**MEMORANDUM**

**DATE:** February 10, 2017

**SUBJECT:** BZA 19418 319 Varnum Street NW – Special Exception relief to permit the conversion of a single-family residential dwelling to a three-unit apartment building

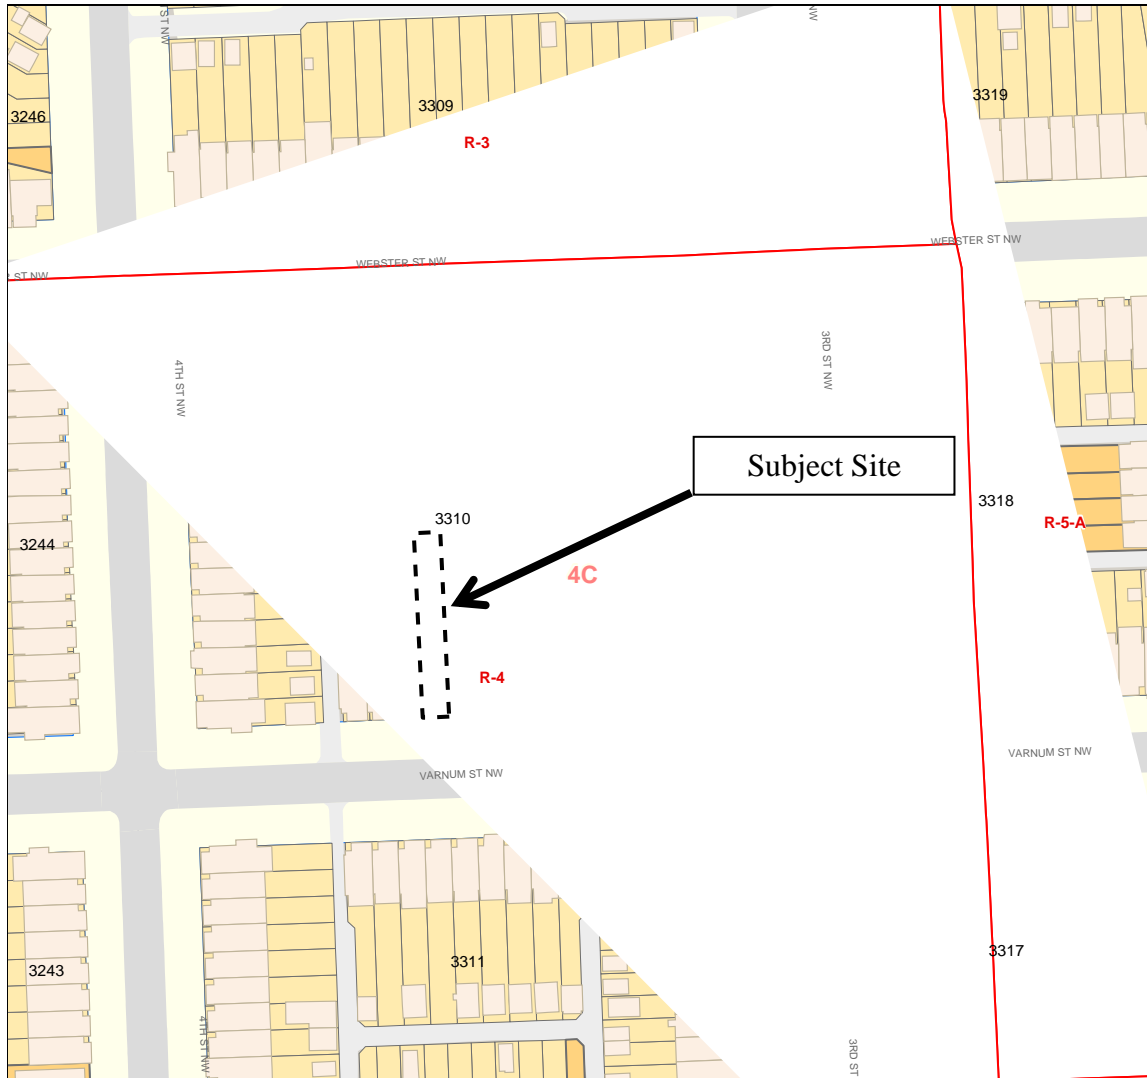
Although the Applicant did not request a waiver of U § 320.2(h), Rooftop Architectural Element, OP believes a waiver would be necessary as the rooftop is being significantly altered; and **would not support** approval of a waiver request for the proposed design.

The proposed addition would extend 20 feet beyond the furthest rear wall of the adjoining properties and the Applicant is requesting a waiver of this section pursuant to U §320.2(l). OP does not support the waiver request, as it would permit an addition that is not in keeping with the scale and character of other properties in the square. While the lots in the square are relatively deep at 140 feet, the properties have generally maintained a consistent depth of rear wall. The proposed addition would introduce a three-story volume at the rear of the property that would not be consistent with the sleeping porches and open decks found at other properties in the square.

Although the Applicant is proposing to maintain the existing dormer and has not requested a waiver of this subsection, the proposed third floor addition would begin 5 feet behind the front façade and would alter rooftop architectural elements original to the house. The proposed addition also would result in a material change to the rear elevation and roofline of the property. OP, therefore, does not support a waiver of this subsection for the design as currently proposed.
